June 27, 2003

ULNRC- 04592

**DOCKET NUMBER 50-483
CALLAWAY PLANT
UNION ELECTRIC COMPANY
PROPOSED REVISION TO TECHNICAL SPECIFICATION 1.1,
"DEFINITIONS"; TECHNICAL SPECIFICATION 3.7.3
"MAIN FEEDWATER ISOLATION VALVES (MFIVs)"; AND
STEAM GENERATOR TUBE RUPTURE WITH OVERFILL RE-ANALYSIS
Reference: ULNRC-04845, dated May 9, 2003 (LER 2003-003-00)**

Feedwater Isolation Valves

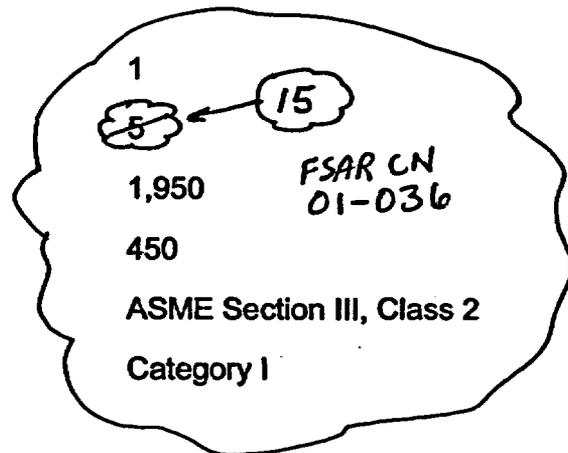
Number per main feedwater line	1
Closing time, sec	5
Body design pressure, psig	1,950
Design temperature, F	450
Design code	ASME Section III, Class 2
Seismic design	Category I

← INSERT J →

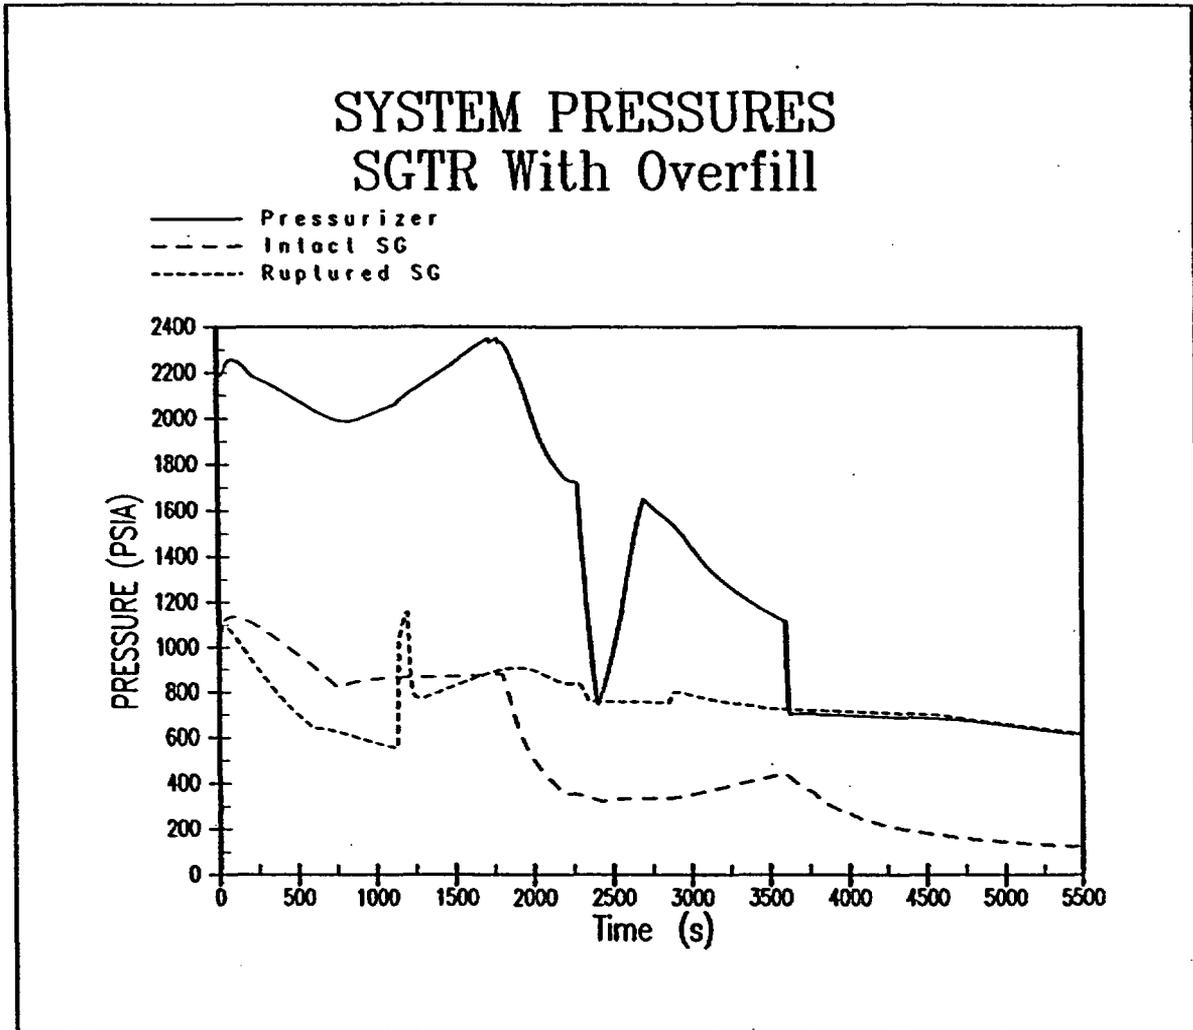
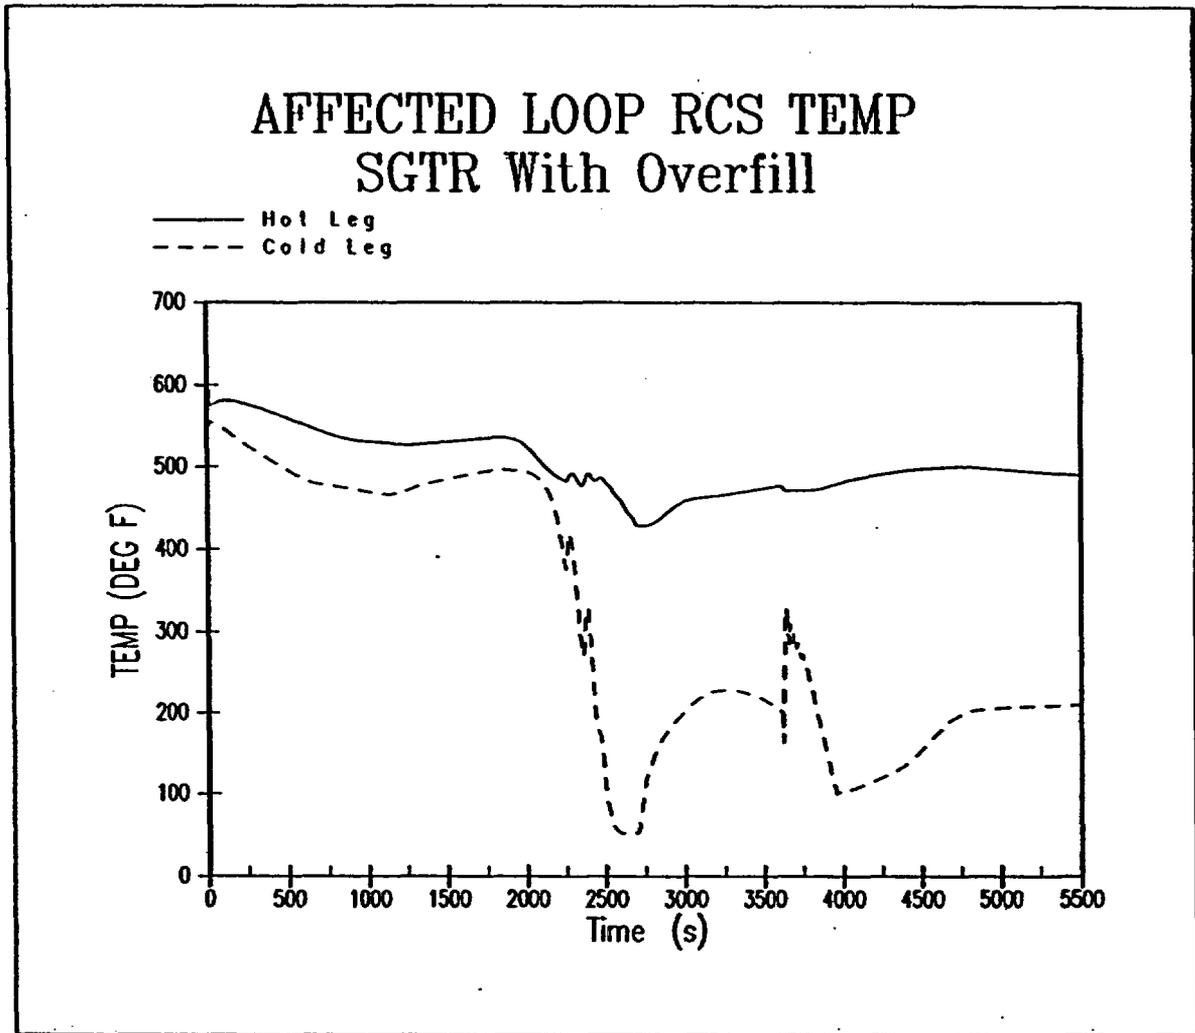
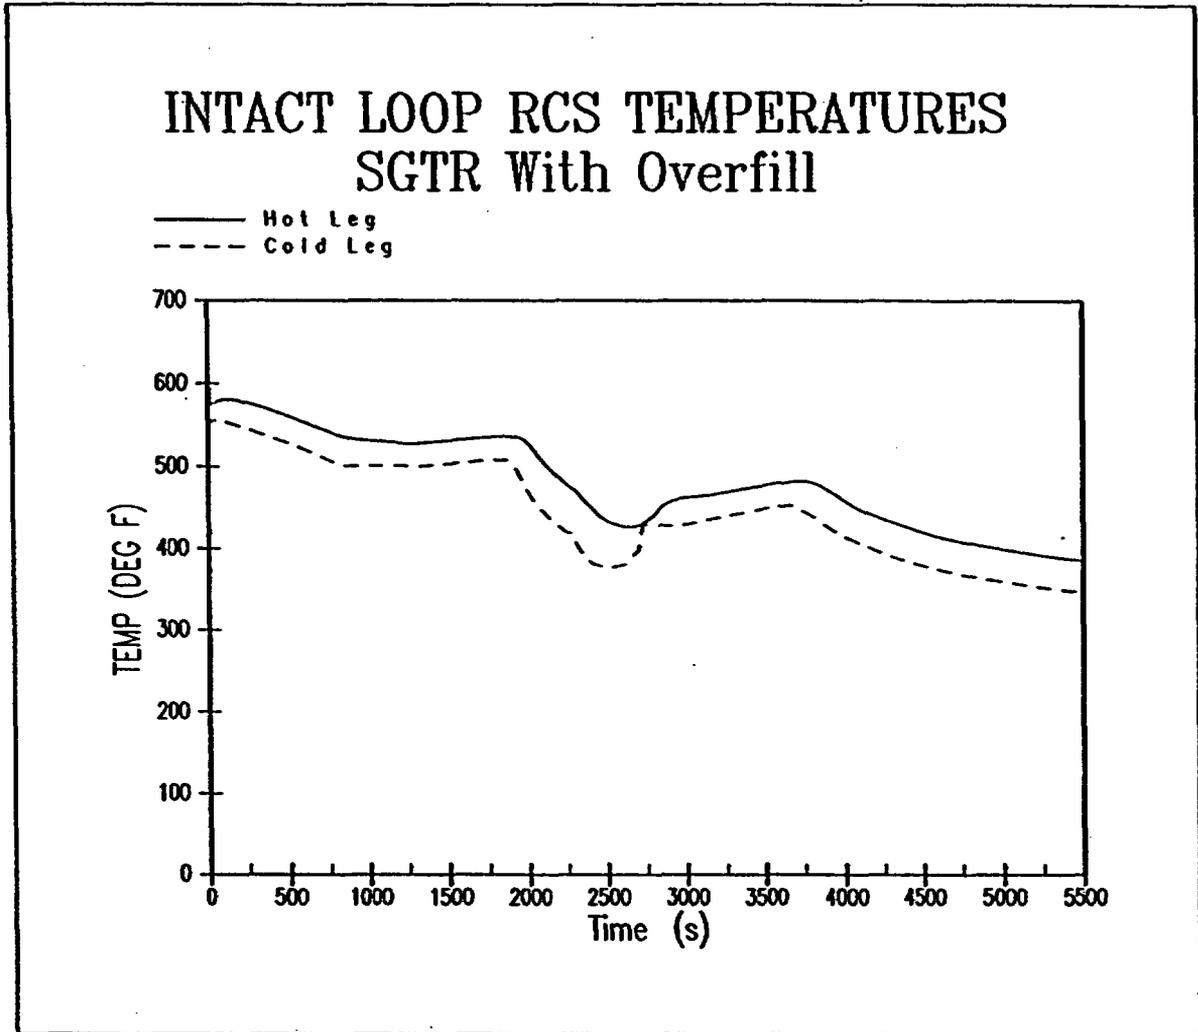
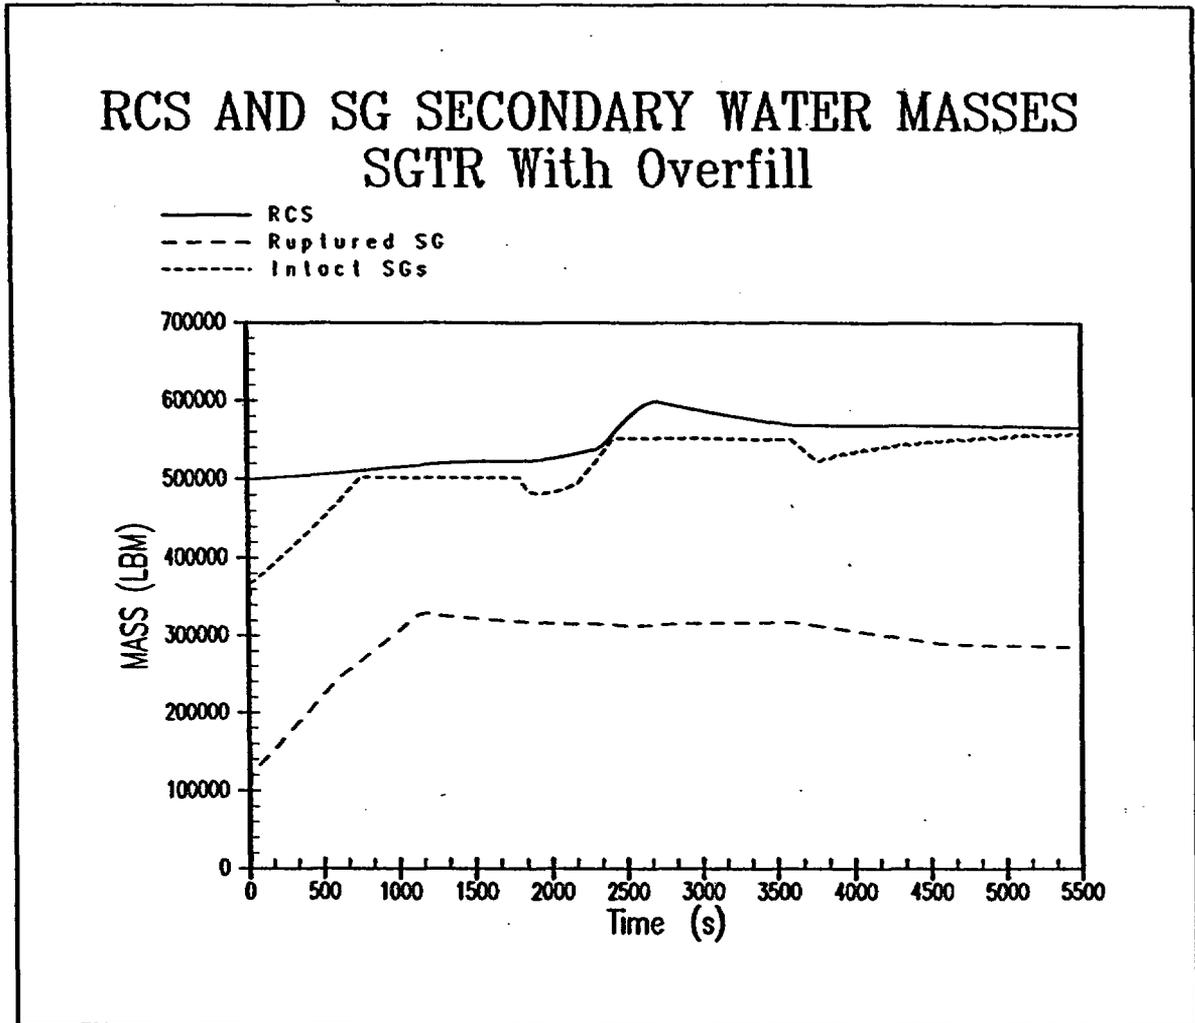
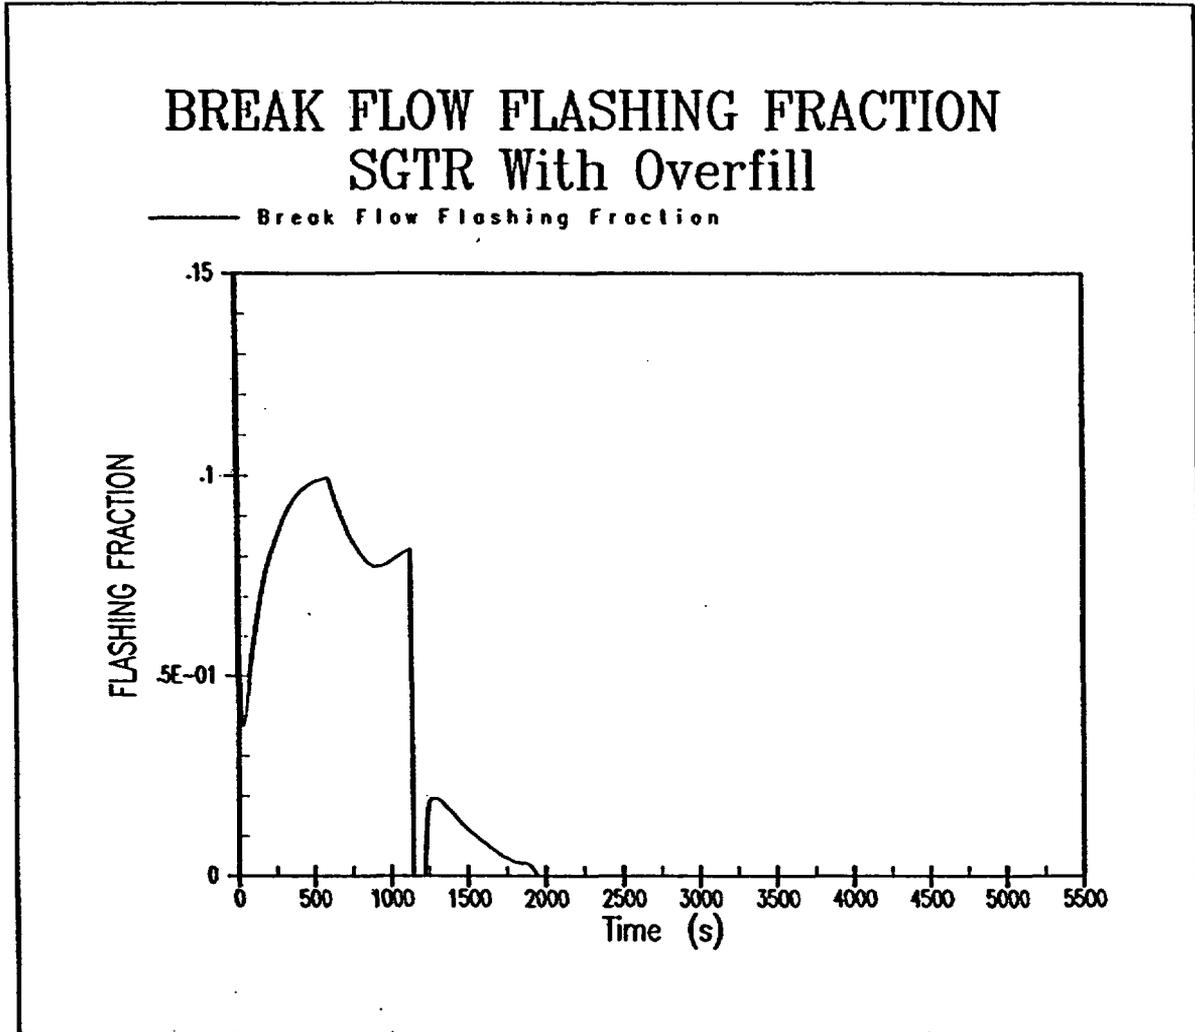
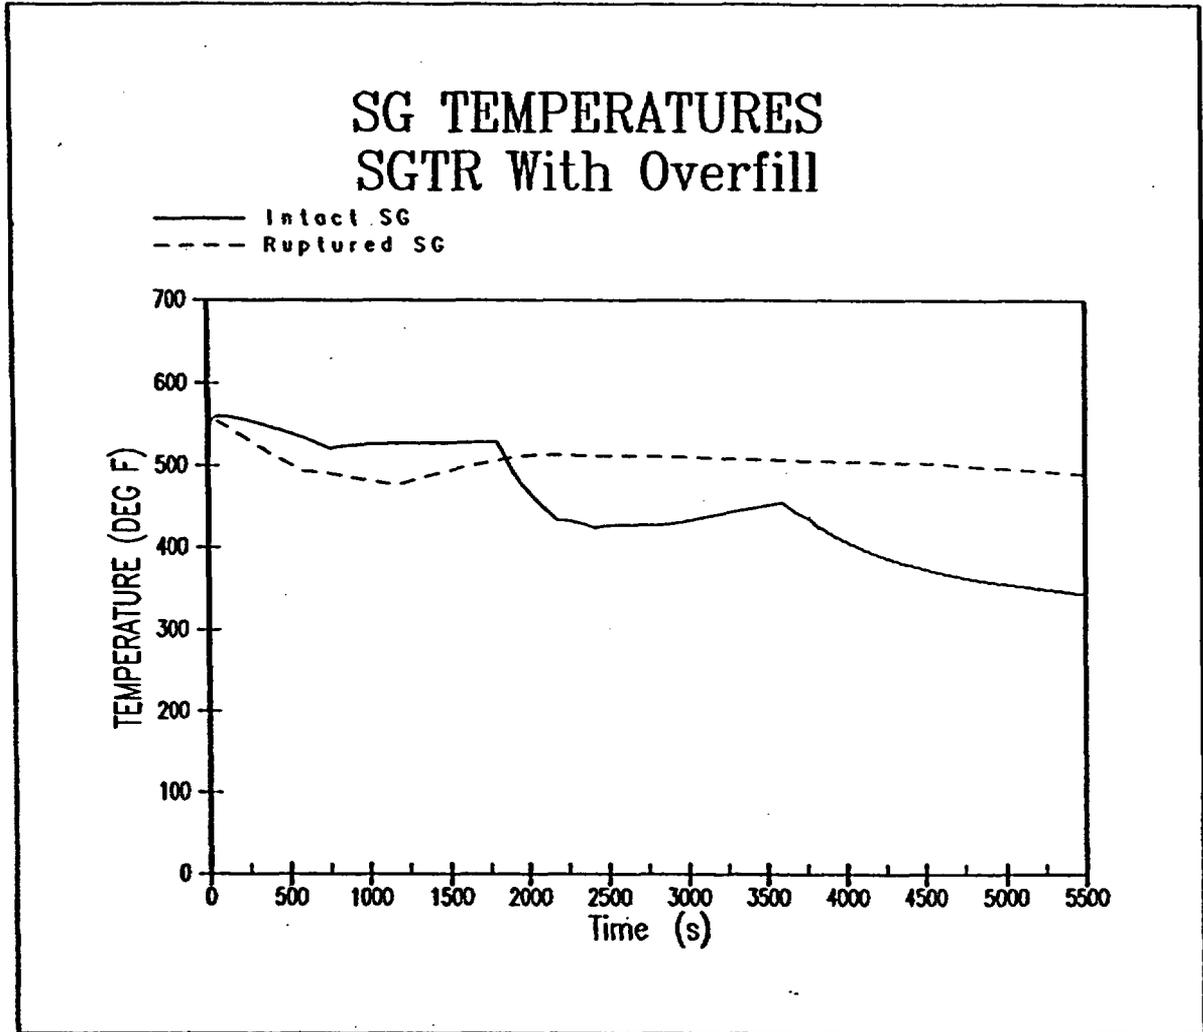
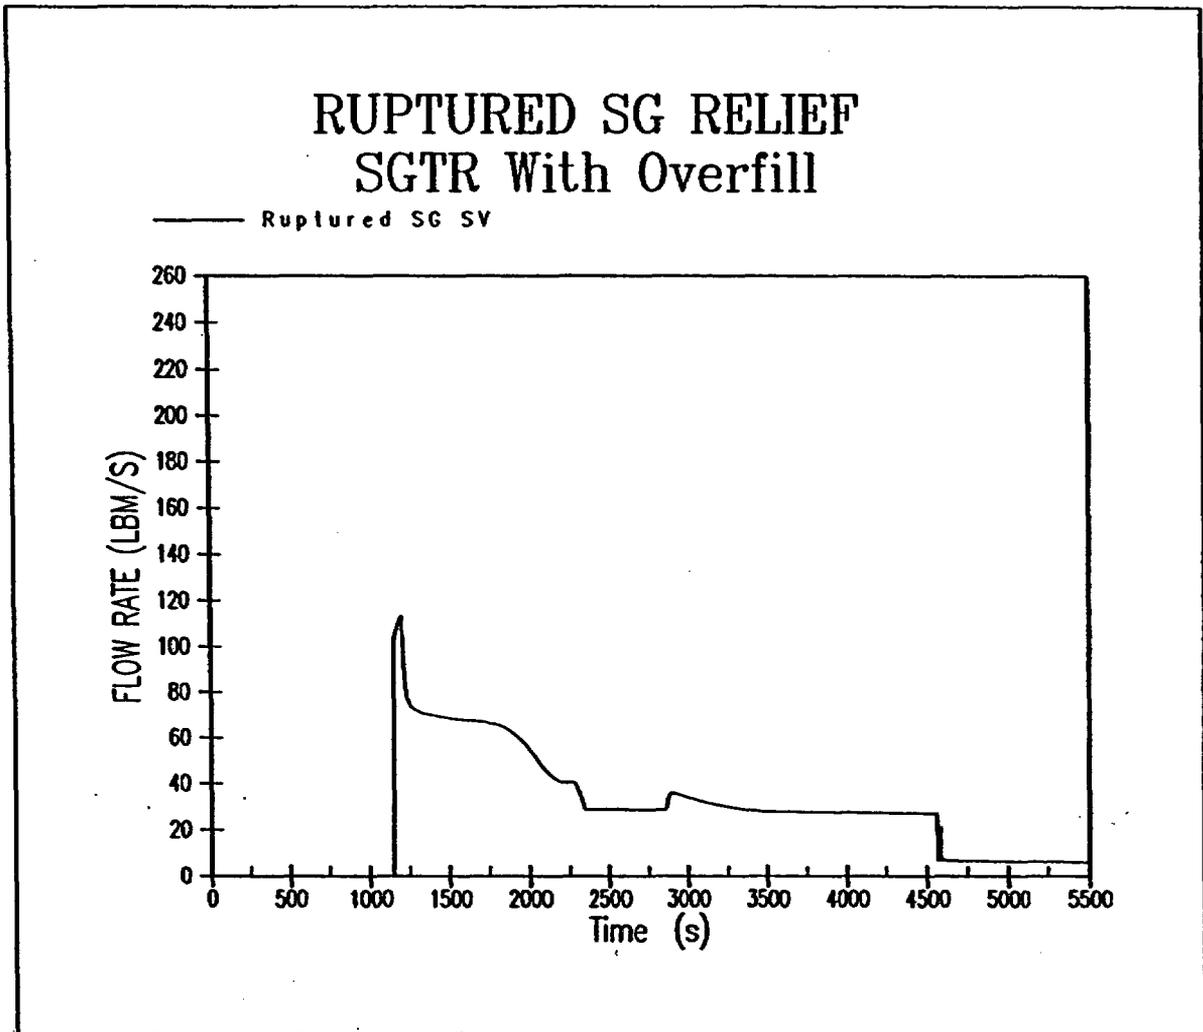
- The Section 15.6.3.1.3 dose analysis conservatively modeled a constant break flow rate. For the analysis of doses for the overfill case the transient break flow rate from the RETRAN analysis presented in Figure 15.6-3.2.i is used, up until the time when water relief stops. This is consistent with the analysis approved in Reference 3.

- k. The ruptured SG releases are modeled using the RETRAN analysis results presented in Figure 15.6-3.2.g. In the calculation of doses for the cooldown to RHR conditions it is assumed that a steam flow rate of 8 lbm/sec is maintained due to the failed open safety valve. Thus, 144,000 lbm of steam is released from the ruptured SG in the 5 hours from break flow termination until RHR conditions are reached.

- l. The intact SG releases are modeled using the RETRAN analysis results presented in Figure 15.6-3.2.h. In the calculation of doses for the cooldown to RHR conditions it is assumed that 4000 lbm of steam is released from the intact SGs from the time of break flow termination. This value was conservatively calculated
